PES UNIVERSITY
3rd SEMESTER

Errata for
DIGITAL DESIGN AND COMPUTER ORGANISATION
Slides Uploaded to PESU ACADEMY Portal

Errata Last updated 9th October 2020

Sl. No	Lecture Number	Content in the slide	To be Corrected as
1.	UNIT3 Lecture 34 Slide 16

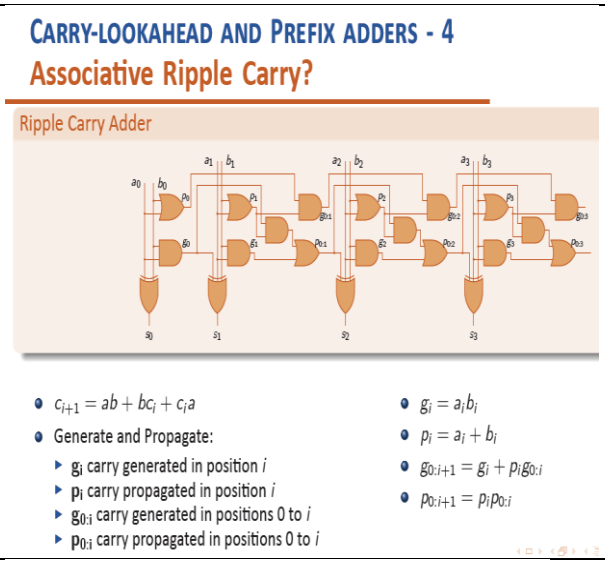
In the figure the labels p0: i and g0:1 need to be interchanged.
2.	UNIT3 Lecture 31 Slide 5

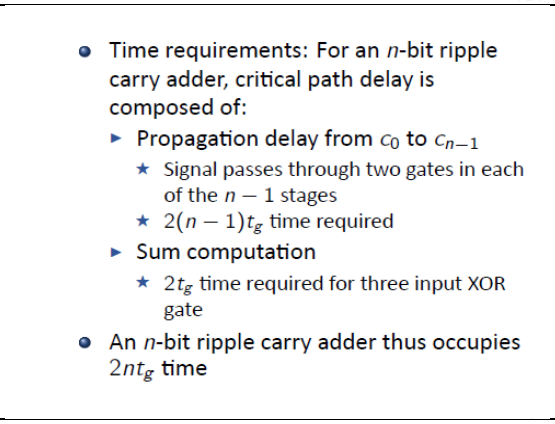
Propagation delay from c0 to c(n-1) should be 3(n-1)tg instead of 2(n-1) tg because although the carry signal passes through two gates in each stage, one of the gates has three inputs which counts as two two input gates..

3.	UNIT3 Lecture 24 Slide 42 till Slide 83

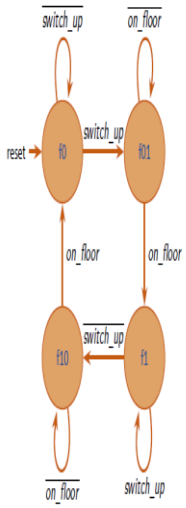
Elevator Example State Tansition Table Current State | Inputs | Next State s_3 s_2 s_1 s_0 | switch_up | on_floor | s_3' s_2' s_1' s_0' 0 0 0 1 | 0 | 0 | 0 0 0 1 0 0 0 1 | 0 | 1 | 0 0 0 1 0 0 0 1 | 1 | 0 | 0 0 1 0 0 0 0 1 | 1 | 1 | 0 0 1 0 0 0 1 0 | 0 | 0 | 0 0 1 0 0 0 1 0 | 0 | 1 | 0 1 0 0 0 0 1 0 | 1 | 0 | 0 0 1 0 0 0 1 0 | 1 | 1 | 0 1 0 0 0 1 0 0 | 0 | 0 | 1 0 0 0 0 1 0 0 | 0 | 1 | 1 0 0 0 0 1 0 0 | 1 | 0 | 0 1 0 0 0 1 0 0 | 1 | 1 | 0 1 0 0 1 0 0 0 | 0 | 0 | 1 0 0 0 1 0 0 0 | 0 | 1 | 0 0 0 1 1 0 0 0 | 1 | 0 | 1 0 0 0 1 0 0 0 | 1 | 1 | 0 0 0 1	on_first should be equal to 1 in state 3(0100) instead of the incorrectly mentioned on_first should be equal to 1 in state 4(1000) 'lift_down' be 1 in state 4 (1000) according to the state diagram

4.	UNIT 2, Lecture 14 Slide 20

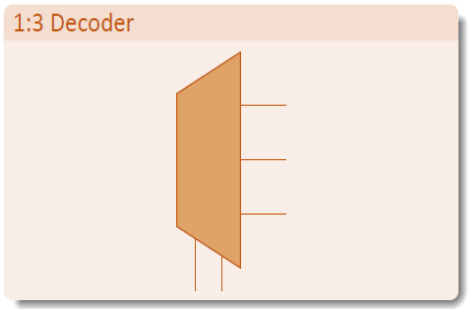
To be corrected as 2:3 decoder
5.	UNIT 2 Lecture 14 Slide 12-16

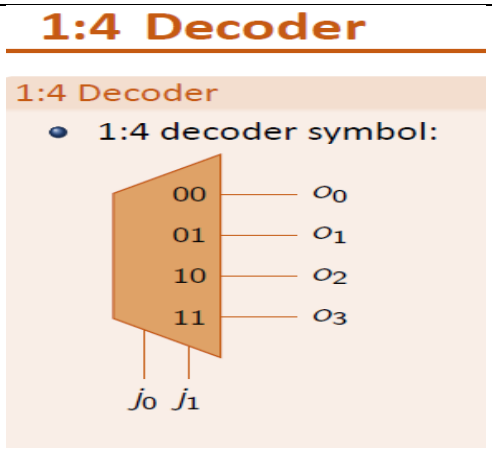
To be corrected as 2:4 decoder
